To: Quinault Indian Nation

From: Natural Systems Design and Saturna Watershed Sciences
Kevin L. Fetherston, PhD, PWS
Susan Dickerson Lange, PhD, PHG
Torrey Luiting, MS, PWS
Tim Abbe, PhD, PEG, PHG
Paul Pittman, PEG

Date: June 3, 2022

Re: Critical Review of the December 2021 Chehalis FRE Vegetation Management Plan

Figure 2. Landcovers mapped along cross section within an example portion of reservoir area upstream of proposed FRE facility.

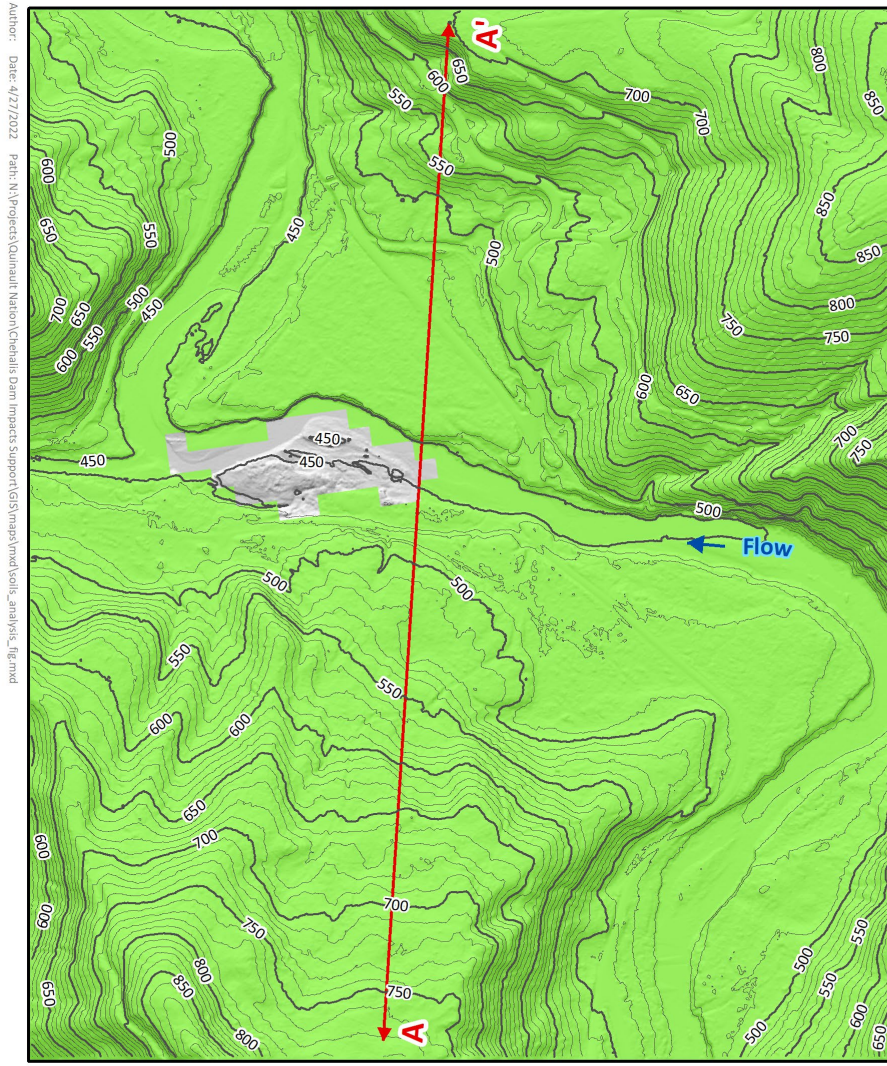
Both the *Mixed Coniferous Transitional Forest* and *Deciduous Riparian Forest with some Conifers* plant communities have well developed overstory and understory vegetation. *Coniferous Forest* dominated by Douglas fir would have a well-developed tree stratum and dense canopy with poorly developed understory vegetation (Figure 2). This community is adapted to generally dry upland soil conditions on the well-drained hillslopes surrounding the river channel and riparian zone. The *Logged and Replanted* communities have variable degrees of vegetative cover depending on the length of time since replanting, but generally poorly developed overstory and understory vegetation on dry well drained soils (Figure 3).

The VMP proposes to convert the Debris Management Evacuation Treatment Area and the Final Evacuation Treatment Area (Figure 4) from Coniferous Forest, Transitional Forest, and Logged/replanted slopes to a 'revegetated community of flood tolerant' shrubs and trees in the first few years of the construction schedule (i.e., in advance of the first activation of the proposed FRE facility and formation of the reservoir) (Figures 4 and 5). The Riparian Area Treatment would be applied within 200 feet of the Chehalis River and Type S streams (i.e., Crim Creek) and within 75 to 150 feet of smaller tributaries depending on their mapped WDNR stream type. The VMP also proposes to install 'flood tolerant' species in the Final Evacuation Treatment Area on the hillslopes with well-drained upland soils (i.e., Bunker loam, Katula cobbly loam, Lytell silt loam and Winston loam) (Figure 3, NRCS Soil Mapper 2020).

Figure 5. Proposed planting areas looking downstream along example cross section illustrating existing vegetation and proposed planting zones.

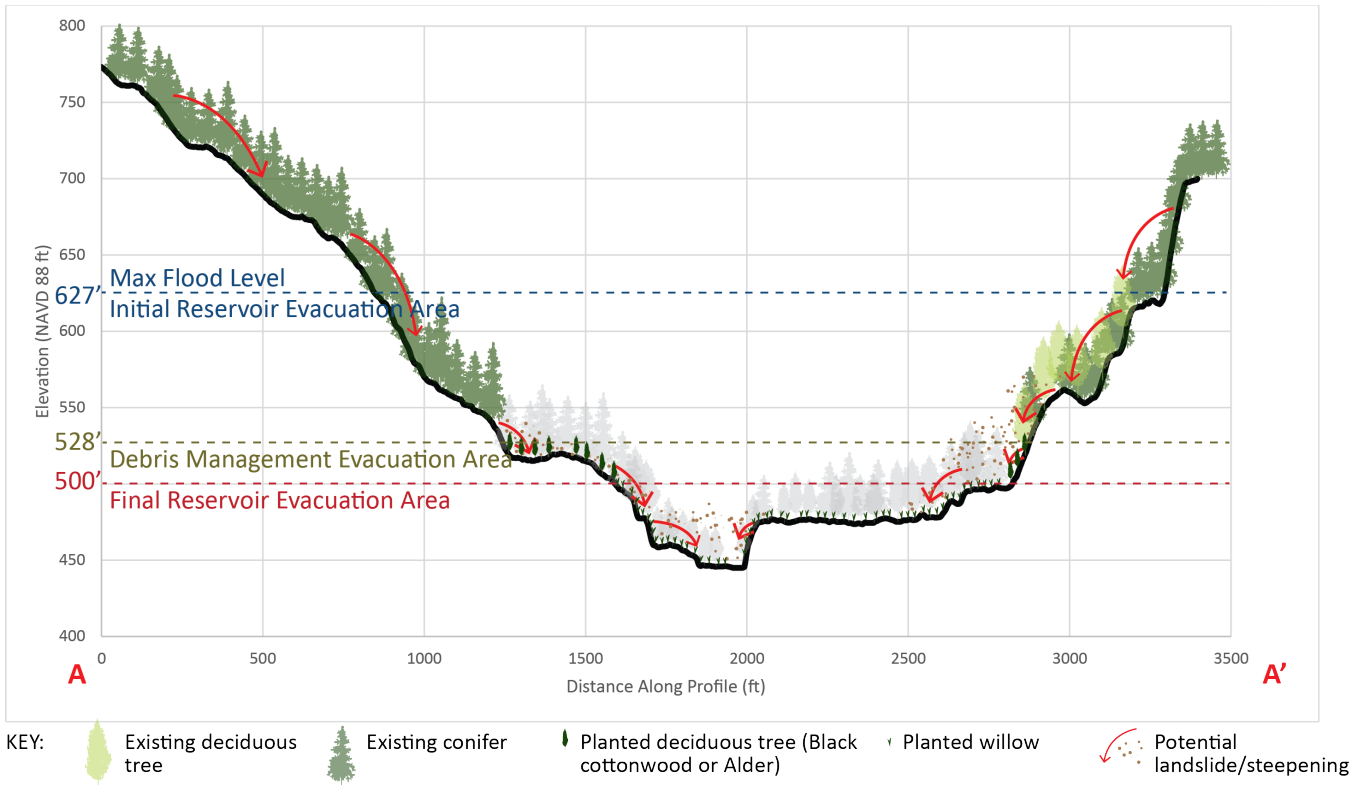
Planting flood tolerant species on slide-prone hillslopes with well drained soils and existing forest and shrub cover is fatally flawed (Figure 5). The VMP fails to consider the dry, well drained soils of these areas, as well as the density of existing plants and shade of the existing conifer dominated forest vegetation. Further, the proposed spacing/density (VMP Section 6. 4, page 6-4) is an aggressive planting design given plants are, in theory, to be inter-planted within existing forested and shrub vegetation. For example, the proposed spacing for the Riparian Treatment Area is for all shrubs to be planted 3-5 feet on-center and Pacific willow trees 6-10 feet on-center (VMP Section 6. 4, page 6-4). It is difficult to see just how this density of planting design will be accomplished within existing forested and shrub communities as described in the VMP. There will simply not be enough room to plant at these densities let alone having these wet soil-adapted species survive both sustained inundation, submergence and the predominantly dry upland conditions that occur between reservoir filling events.

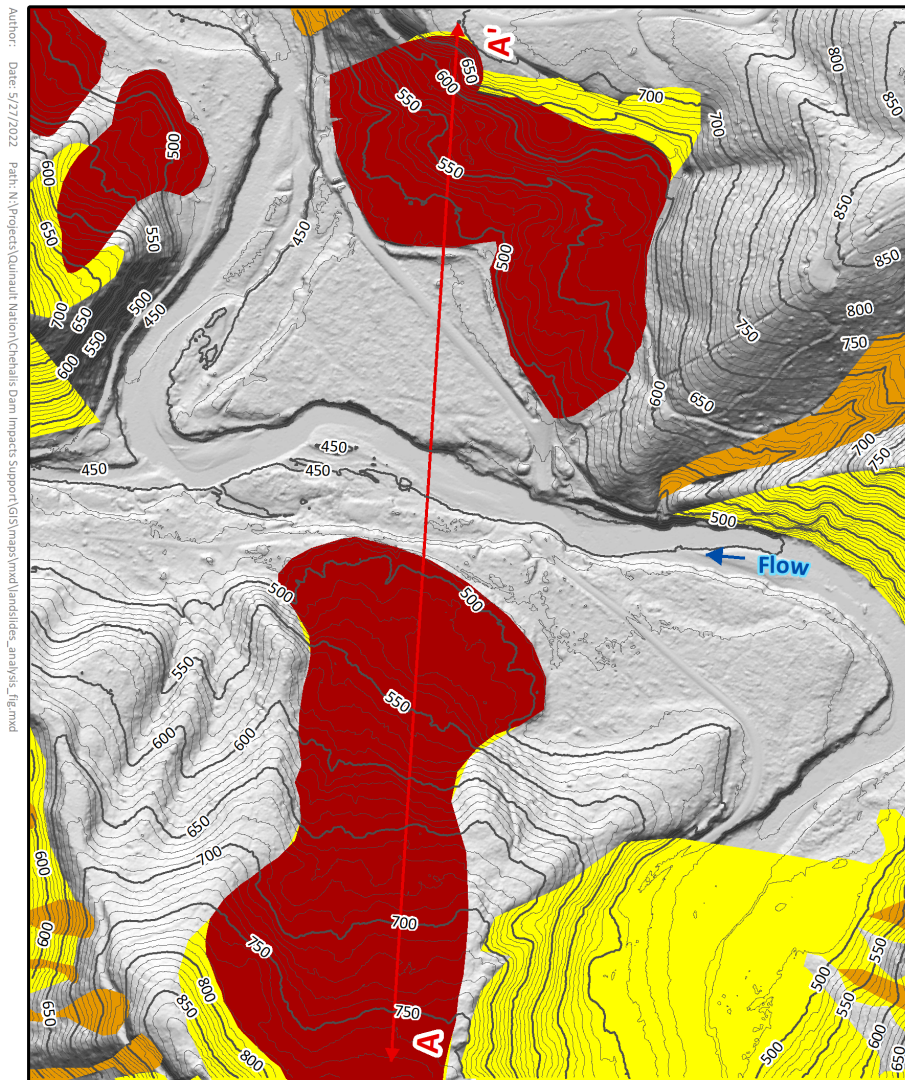
Further, given the high probability of extensive hillslope destabilization and landslides (as presented below), it is our opinion that successful revegetation in many areas will be impossible to attain. The result of the loss of deep-rooting woody vegetation will result in a loss of hillslope stability, especially in steeper areas of existing

hillslope mass failures (e.g., the landslides mapped in the DEISs slated for Debris Management Zone harvest, example cross section Figure 9; see also Figure 20).

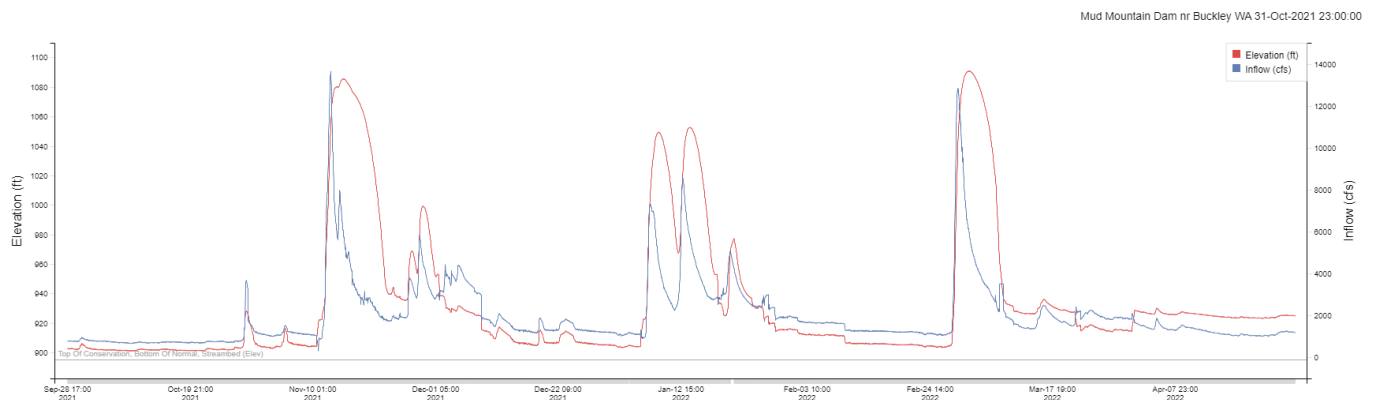
Based on an elevation threshold of 970 feet, which is somewhat lower elevation than the upper bound and therefore within the Final Evacuation Zone and more representative of inundation duration within that zone, the observed duration of inundation events included: 10 days (November 12-22), 2 days (November 28-30), 6 days (January 6-12), 5 days (January 12-17), and 7 days (March 1-8) (Figure 10). These inundation durations are even shorter if the upper bound elevation of approximately 1,045 feet is considered relative to the observed data.

Thus, the vegetation communities at MMD that are presented as an analog for the potential vegetation community in the FRE Final Evacuation Zone are subject to more frequent and much shorter duration inundation. This example is based on visual inspection of one winter of data only. However, it suggests that **the lack of a quantitative assessment of the frequency and duration of hydrologic conditions in the MMD reservoir results in a serious omission and renders the use of MMD as an analog to support viability of the VMP invalid. The existence of vegetation at MMD that is adapted to frequent and shorter duration inundation is not evidence for the viability of the proposed vegetation during and after FRE operation.**

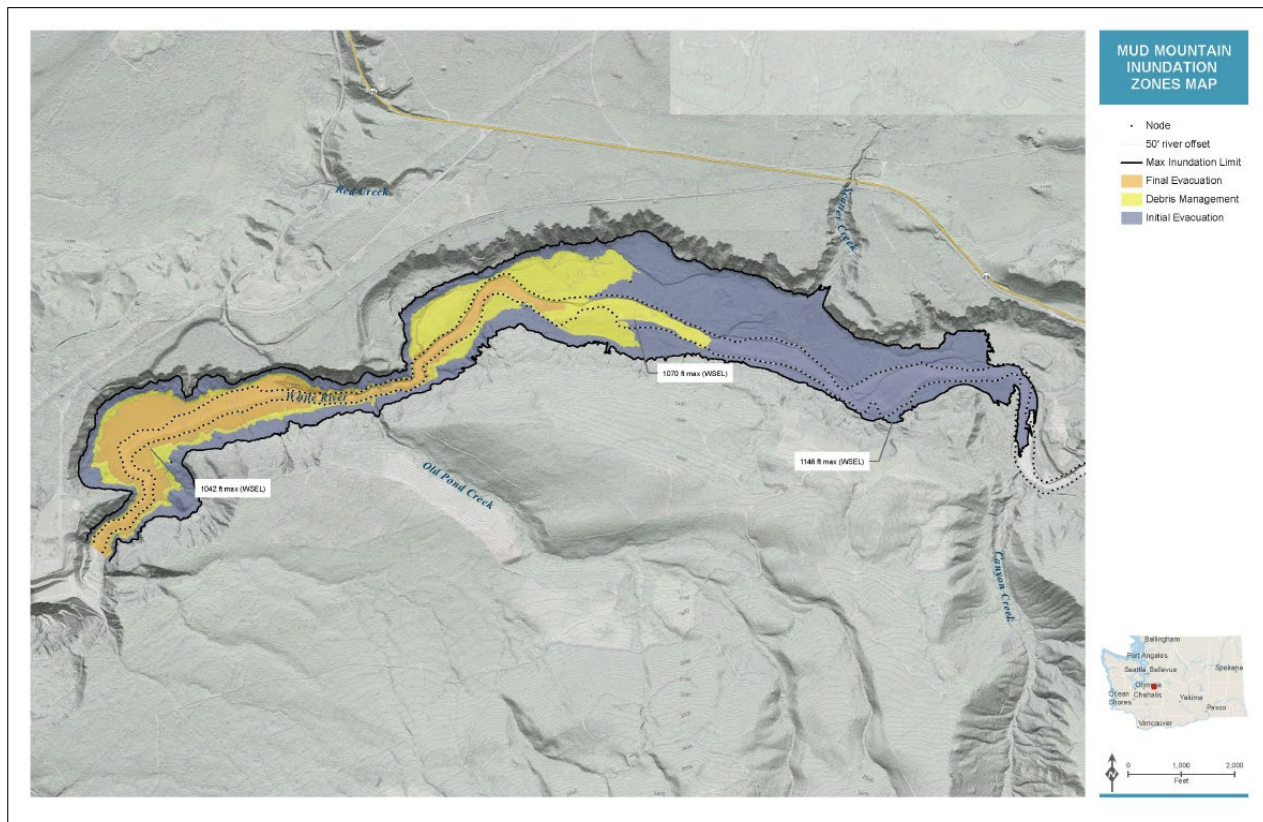
MMD and the proposed FRE facility also differ in the frequency and duration of impoundment within their analogous final evacuation zone, debris management zone, and initial evacuation zone. This key difference suggests that MMD is not a reasonable analog on which to base the tree and shrub species proposed for interplanting or to validate the assumptions made in the VMP regarding mature height providing shade to the river channel. The Water Temperature Model Sensitivity Analysis asserts that MMD “floods to similar depths and for similar durations as the proposed FRE facility” (3.2.1, p 3.5), but this similarity is unsupported by data.

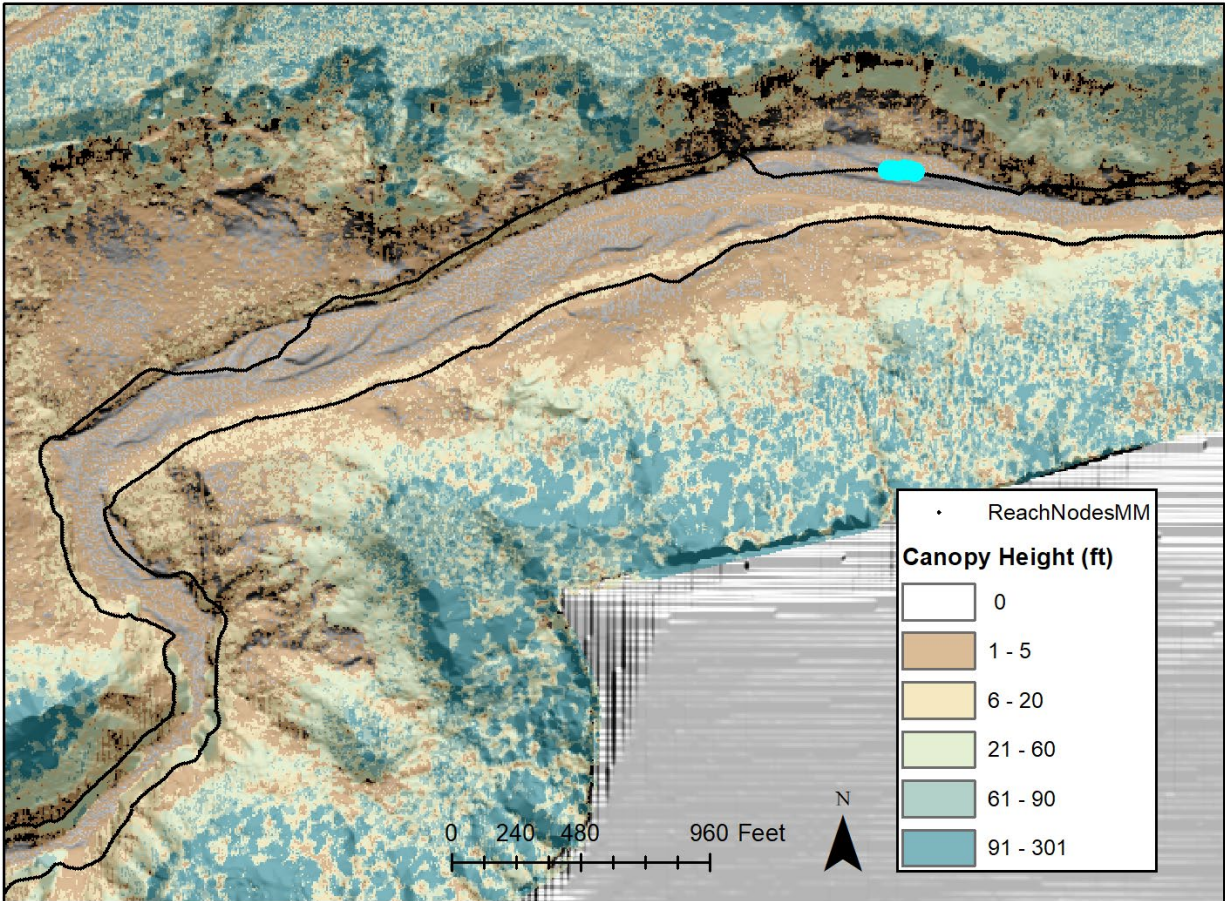
However, the supporting analysis is erroneous. The lidar canopy height data that were used in the analysis and are included as Attachment C of the Water Temperature Model Sensitivity Analysis show that **the canopy height data from which the majority of the values were extracted has erroneously high vegetation values, with heights of 60-110 feet along and through the active channel (Figure 12)**. Canopy heights of over 20 feet are present within over 3,500 feet of the active channel in this dataset. The presence of vegetation in the active channel, and within the zone that was clearly impounded when the 2011 lidar data were collected (as evidenced by the smooth water surface in the hillshade map) are indicative of problems with the underlying dataset. The

2003 lidar dataset shows a more reasonable representation of canopy heights without the obvious problems in the 2011 dataset (Figure 13). However, based on examination of the attribute table associated with the nodes in Attachment C (Figures 12 and 13), the vegetation values that were extracted at each node and then averaged are largely based on the erroneous 2011 data rather than the 2003 data when the reservoir was not impounded. Thus, the average vegetation height of 28 feet that is presented as validation of the vegetation height assumptions in the Water Temperature Model Sensitivity Analysis is **based on an average that includes large swaths of erroneously tall vegetation.**

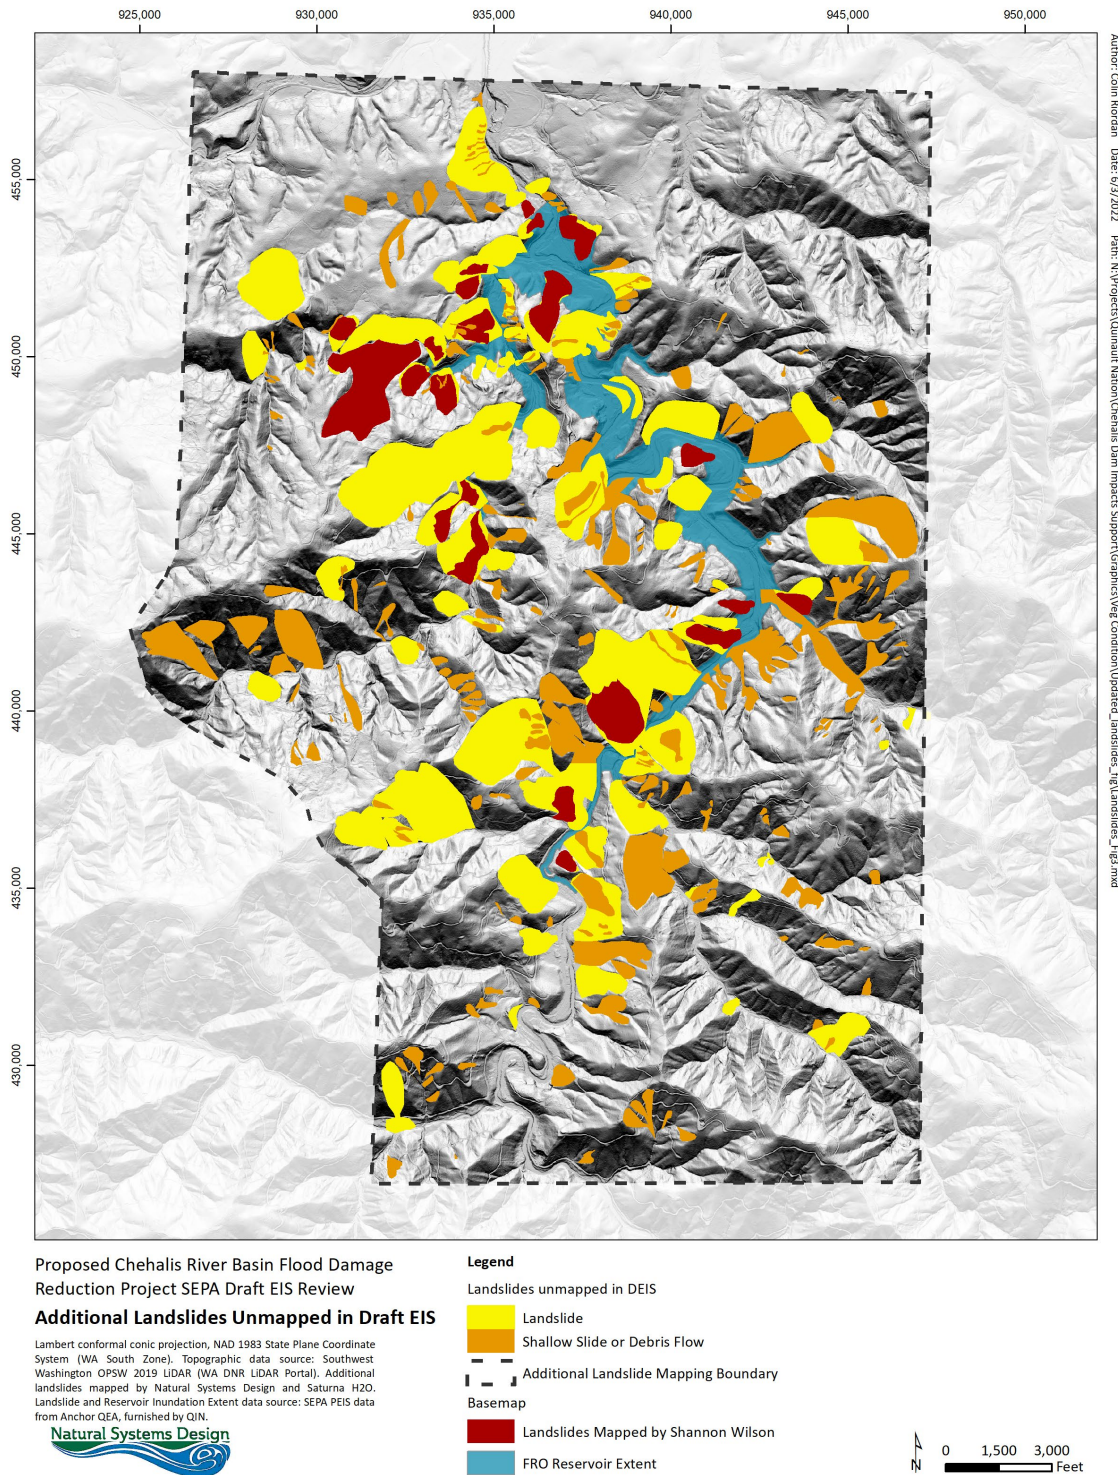
The *SEPA Geology Technical Memo* (NSD and Saturna Watershed Sciences 2020a) critique of the SEPA DEIS Earth Discipline Report and related geotechnical analyses, demonstrated that the degree of slope stability, history of and potential for landslides in the FRE facility reservoir area is grossly underestimated. In that analysis, NSD and Saturna Watershed Sciences (2020a) performed a desktop landslide mapping (Figure 20) that demonstrated:

1. widespread slope instability within the watershed,
2. a greater potential for slope instability resulting from vegetation removal and fluctuating reservoir levels than was disclosed in the DEIS, and
3. the resulting underestimation of sediment inputs into the Chehalis River from landslides and erosion, and consequent water quality and aquatic species and habitat impacts.

As illustrated in Figure 20, the proposed FRE facility reservoir would be located within a landslide-prone landscape. Landslides and mass hillslope failures have repeatedly occurred throughout the reservoir area under somewhat intact forest conditions. The legacy of forest clear cuts and industrial forestry has resulted in a system with large areas of increased slope instability compared to historic background rates.

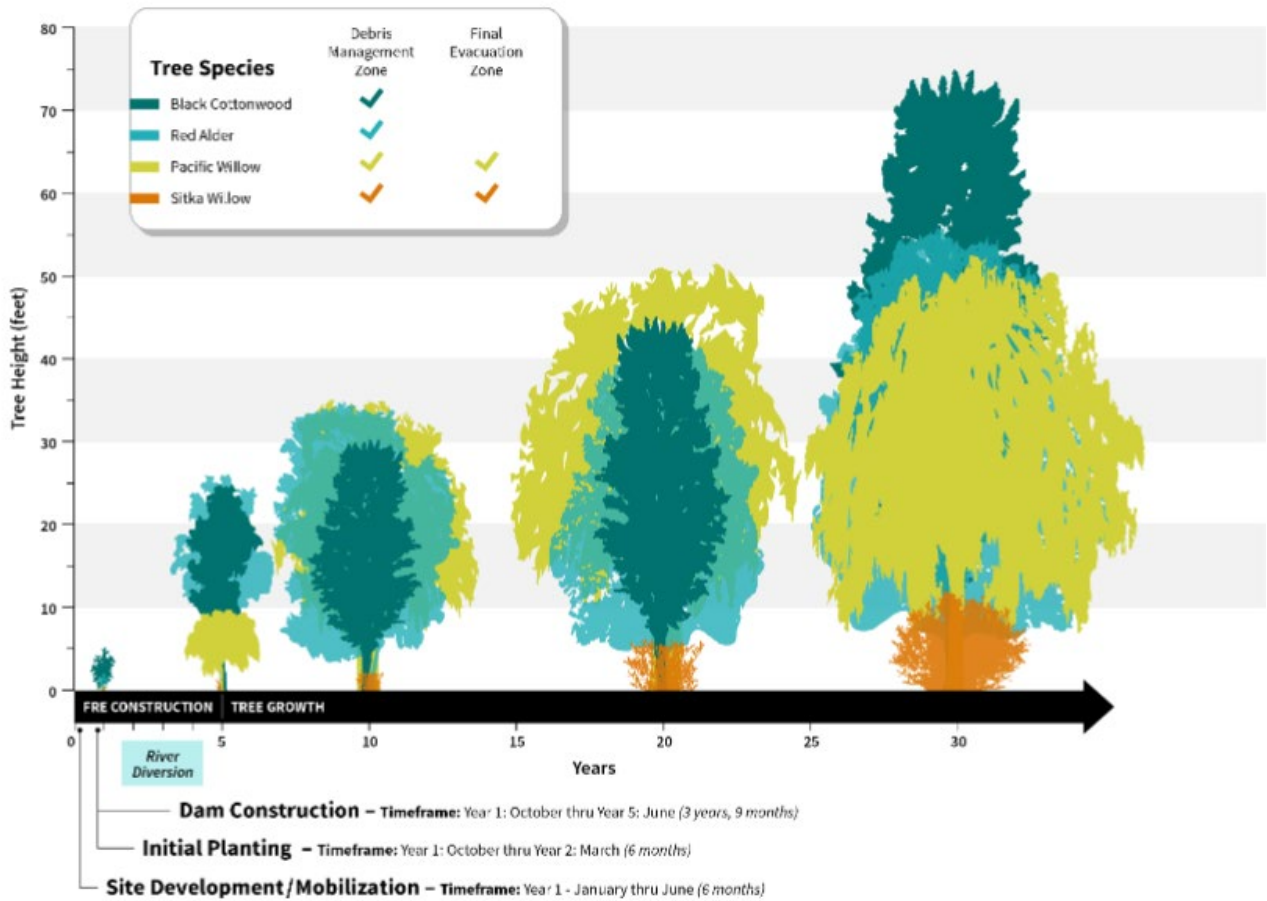
The second flawed assumption is built into the quantification of stream temperature impacts during two years of simulation, over which time riparian vegetation heights are assumed to be at their mature potential. However, mortality due to 30+-days of inundation and submergence under 212 feet of water (e.g., maximum water depth in the Final Evacuation Area) is unaccounted for. After each inundation event, significant mortality will occur. The worst-case scenario would be no trees or shrubs of a stature sufficient to shade the river channel over multiple years following each FRE operation event. Assuming there is recolonization and re-growth of willows during the interval between inundation/submergence events, the time to reach 20 feet is at least > 5 years, as supported by Figure 7 of the VMP (Figure 22 below). **Thus, there are at least 5 years after each inundation event during which the assumption of 20-foot vegetation is invalid. To appropriately characterize the potential effect of the VMP on stream temperature, the duration for which vegetation is at different heights needs to be explicitly included.**
